N5181A-05**S E R V I C E****N O T E**Supersedes:
None**N5181A MXG Analog Signal Generator**

Blank (Dark) LCD front panel may be caused by shorted LCD wires.

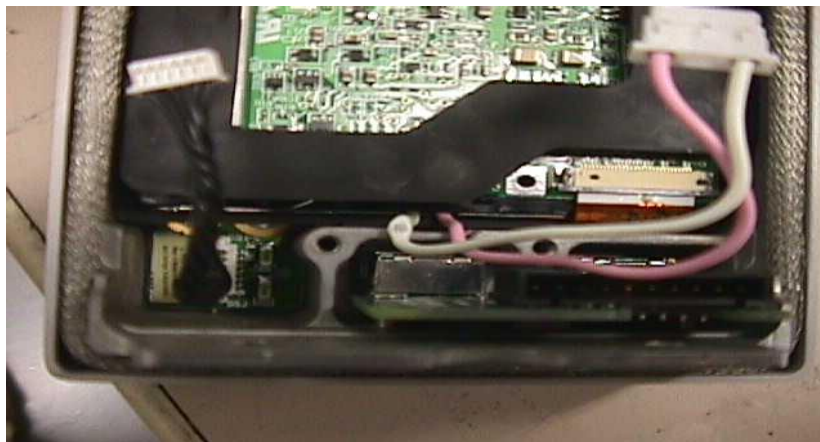
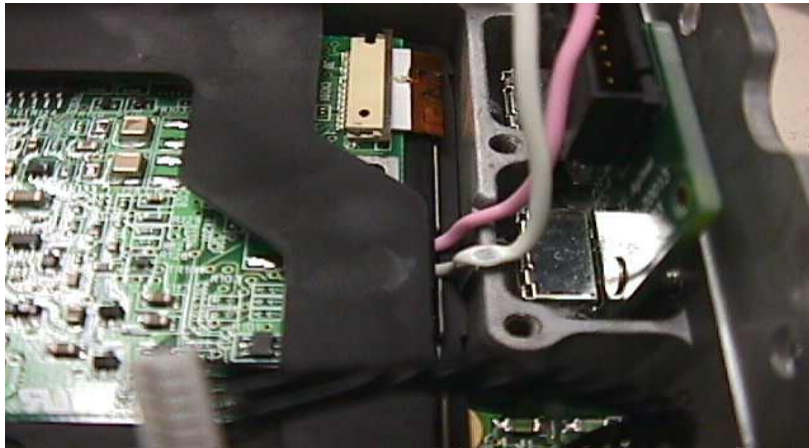
There has been a few random N5181A MXG Signal Generators discovered in the field with pinched Liquid Crystal Display (LCD) power leads. Though this is not a safety concern, the pinched LCD leads may overtime, become shorted resulting in a dark LCD display.

A N5181A MXG Signal Generator that appears to be operating correctly; unit turns-on, fans are functioning and the green power-on switch LED is visible but the front panel LCD screen is dark, may be the result of shorted power leads.

See example images below:

It is suggested that at the time of contact, the LCD leads be inspected for the possibility that the LCD leads are pinched. The LCD leads should move freely as they pass between the sub-panel sheet metal and the front panel casting. When in doubt, remove the front panel sub-panel in accordance with the MXG Service Guide. If the leads are found pinched, but no short has occurred. Reposition the affected lead(s) and if deemed necessary, apply insulating tape to the affected area. Re-assembly the front panel according to the MXG Service Guide ensuring the leads are no longer pinched.

When troubleshooting a MXG with a dark LCD, inspect for the pinched power leads as a possible cause of the dark display. If the leads are found pinched resulting in a physical short, replace the LCD assembly (P/N: N5180-60024) in accordance with the MXG Service Guide.

Additionally, it is recommended when LCD leads are uncovered as being shorted, the front panel Key Pad (P/N: N5180-60021) should also be replaced. While there is no direct empirical proof that the RPG on the Key Pad assembly has been damaged, a connection between shorted LCD lead(s) and the possibility of latent future RPG failures has been made, leading to a proactive desire to replace both assemblies.
